RE: FORESTWAY SHOPPING CENTRE AMENDED REDEVELOPMENT REVIEW OF TRAFFIC MATTERS RAISED IN SUBMISSIONS

Forestway Shopping Centre Redevelopment

Road Safety Review

Figure 1: Proposed entry/exit intersection (note – signalised pedestrian crossing is existing)

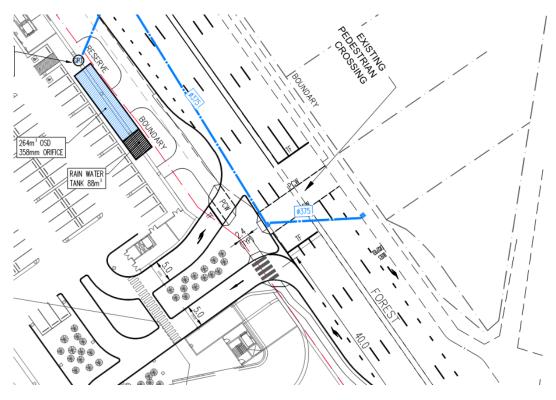
Findings	Recommendations	Suggested Layout	Outcomes (+ see attached)
Treatments For pedestrians walking northbound along the frontage of the site, the proposed works would provide a marked pedestrian zebra crossing (at the vehicle entry lane) followed by a signalised pedestrian crossing (at the vehicle exit lane). The differing treatments may be confused by users, – if a pedestrian has right-of-way across one lane, they could assume they have right-of-way across an additional lane immediately following and proceed into an active vehicle lane. This is particularly the case where there is no significant change in road function between the two driveways, in contrast to pedestrians continuing to the crossing at Forest Way where there is a major change in road function	Provide an offset between the two driveway crossings to alert pedestrians to the change in environment and require an active change in behaviour between the two crossings. An example for a mid-block crossing (from the Queensland Department of Transport and Main Roads Supplement to Austroads Guide to Road Design Part 4) is shown below.	\$ \tag{6375}	The pedestrian footpath route will be required to be within the road reserve. Movement of the zebra crossing within the site would be outside the road reserve and would interfere with a proposed plant room for the development. As an alternative, an inverse solution is proposed – the zebra crossing can be moved slightly closer to the road, and the signalised crossing further within the site. This proposal also has the added benefit of providing additional pedestrian storage space on the island by increasing the distance between the Forest Way crossing and the driveway crossing.

Findings	Recommendations	Suggested Layout	Outcomes (+ see attached)
and pedestrians may be more alert. It is acknowledged that volumes of pedestrians along the frontage are relatively low and the main development desire line does not follow these crossings, however this risk item carries a high consequence due to potential pedestrian-vehicle collisions.

2. Diagonal Shortcuts Pedestrians cutting diagonally across the road, or rushing for a flashing signal, has been observed at the current site. The provision of the new signalised exit lane on an alternating signal cycle would increase safety risks around this space. Pedestrians cutting diagonally from the crossing westbound toward the northbound bus stop (under a green pedestrian signal) would be crossing the vehicle exit lane (which would also have a green signal). Vehicle volumes exiting the site are likely to be low enough to create inconsistent streams and gaps in traffic, which could give a false impression of a safe gap for pedestrians.	Provide pedestrian fencing along the edge of road reserve (north of the exit driveway lane) to deter pedestrian shortcuts in this area. Provide pedestrian fencing along the road median (consistent with the existing treatment south of the crossing) to further deter pedestrian shortcuts.	Recommended median fence Recommended edge fence	An additional pedestrian fence can be incorporated into the design, subject to Transport for NSW concurrence for works on the median of the state road. Completion of these works may also require confirmation of any works related to Northern Beaches Hospital Road Upgrade, which involved replacement of the existing median fence.

Findings	Recommendations	Suggested Layout	Outcomes (+ see attached)
3. Visibility of Pedestrians at Entry Driveway The entry driveway requires drivers to give way to pedestrians at a marked pedestrian zebra crossing. Pedestrians travelling northbound would be immediately to the left of approaching vehicles, on the passenger side, at the point of decision for the driver. Visibility to an approaching pedestrian may be difficult and poor, with a potential risk of collision.	Move the zebra crossing further within the site, to provide a more head-on approach to the crossing and a more typical arrangement for all users. Following any changes, ensure pedestrian visibility is maintained around the plant room area such as by a splay or chamfer. This change would also satisfy the recommended offset of crossings.	Ø375 Ø375	Due to the proposed offset crossing in Item 1, and other site restrictions, the zebra crossing could not be moved further within the site. It is proposed that zig-zag line marking be provided within the turning lane to alert drivers, plus advance warning signage.

Findings	Recommendations	Suggested Layout	Outcomes (+ see attached)
4. Width of Entry and Exit Driveways The entry and exit driveways are each 5 metres wide. This is much wider than would typically be required for single lane car movements, particularly as demonstrated by the swept path analysis for B99 vehicles. The excess width may encourage higher-than-normal vehicle speeds through these spaces, which could pose a hazard for pedestrians. Requirement for larger vehicles such as delivery and service vehicles is not shown in the swept path drawings.	Reduce the lane width at both the entry and exit driveway to act as a traffic calming measure and slow vehicles in areas with pedestrian interaction. This change would also increase physical clearances to walls adjacent to each driveway.		The lane width can be reduced within the site. The lane width at the corners is suggested to be retained at the current design width. Lane width within the deceleration is also already low (3.0m) which should assist in traffic calming.

5. Pedestrian Vulnerability to Errant Vehicles The deceleration lane at the entry driveway ends in a tight left-hand turn into the site. In the event of an errant vehicle being unable to make this turn, the vehicle would travel directly onto the pedestrian island in front of the signalised crossing, which is a designated waiting and queuing space for pedestrians.	Provide a vehicle crash barrier at the pedestrian island, to protect pedestrians waiting at the signalised crossing. Reduction in lane width (as recommended above) would act as a traffic calming measure which would also help to improve pedestrian vulnerability risks.	Potential barrier treatment	An F-type concrete barrier could be provided at this location, subject to detailed design and finalisation of the pedestrian crossing location.

- 13. Items 5 and 6 have been addressed by a safety review undertaken by TTW (copy attached). Design changes to the access (relocation of the pedestrian crossing on the entry lane, additional pedestrian fencing and a crash barrier) have been recommended.
